ONSITE SEWAGE DISPOSAL SYSTEM

PROPERTY ADDRESS: 3255 ROSCOMMON DRIVE, GFLENELG, MD 21737

Roscommon Estates

BAT Plan

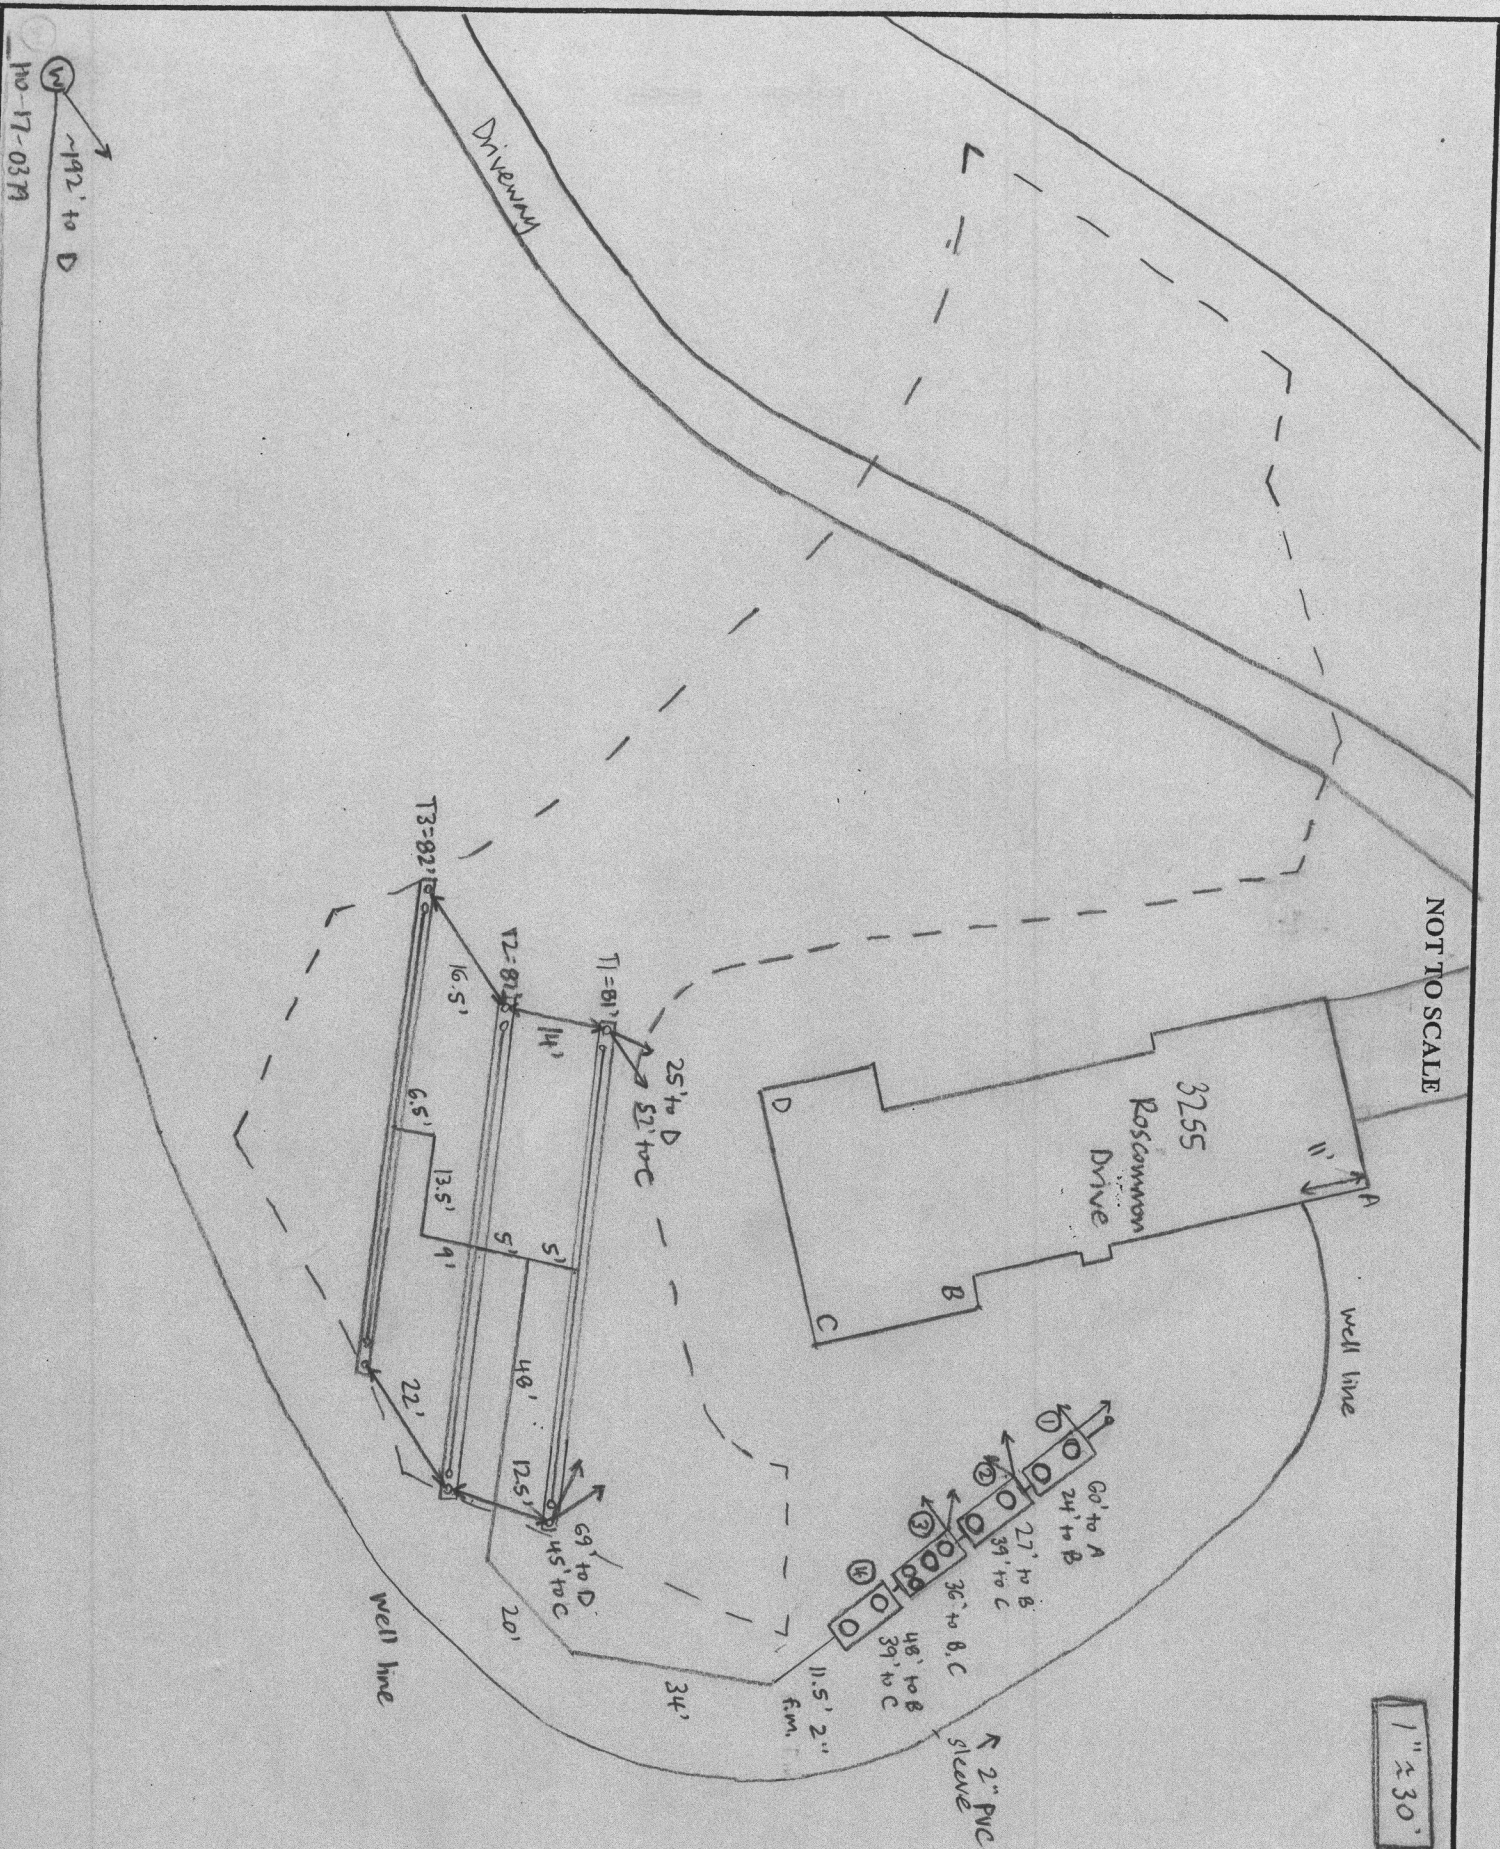
* to Norweco, set by Matt Czekle. Norweco aerators run + alarms sound. Both pump alarms sound. First Wasp panel controls first pump + ^{first} aerator, second Wasp panel controls second aerator + pump to laterals. Checked lateral head heights - just over 24" on lower laterals but 14-16" on upper two laterals. Contact engineer a/b potential pump upgrade. [Corrective action.] BAT startup certification received (SC) 4/1/19 Pump upgraded to 1/2 hp, checked lateral head heights. 4' at lower turnups, 39-40" at middle, and 36-41" at upper. [Corrective action completed.] (SC)

2/19/19 Met Hatfield's + owner Max on site for layout. SDA and initial trenches staked. Shot elevations. T1 ends are within 3" of each other and T2 + T3 are 1-2" different. Tanks staked. Old tank and two drywells uncovered + pumped. (SC)

2/22/19 Hatfield's has first three tanks set. Tanks bedded with #57 stone, digging last tank hole. Soil looks good in tank hole. Old tank + 2 drywells abandoned. Tanks tied into existing sewer line. Tanks moved a foot to stay off drywell. Effluent filter installed in trash tank, NSF standard 46. (SC) 2/25/19 Force main installed to manifold, started digging upper trench. 8' bottom 3' wide using laser to check depths. Start of trench is at an angle 8' bottom starts at obs. pipe 5' from end at stake. Force main installed to drain back to pump tank after pump cycle. (SC) 2/25/19 Upper trench dug, stone + pipe installed in lateral closer to road. 3' wide, 2.5' inlet. (SC) 2/26/19 Trenches complete, middle trench left open at ends and lower trench left open for inspection. 2' to stone 3' wide. Need pump + alarm test and BAT startup certification. (SC) 3/19/19 On site for pump + alarm test. First pump doses ~39 gal

SITE INSPECTION SHEET

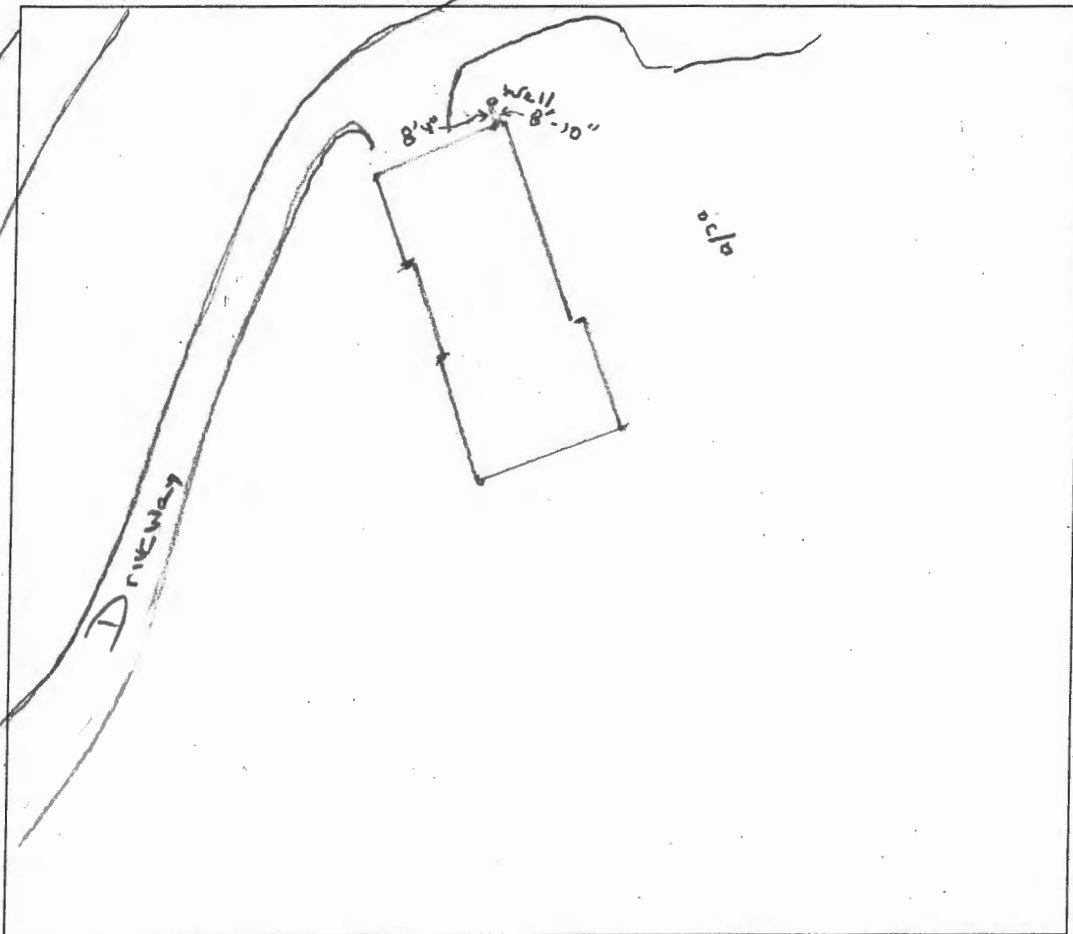
COMMENTS: Well cap had a hole in it & it was only a couple inches above grade. Tank aleanout observed covered w/ bucket. House is vacant/under repair. Instructed owner to replace cap, disinfect well & sample.
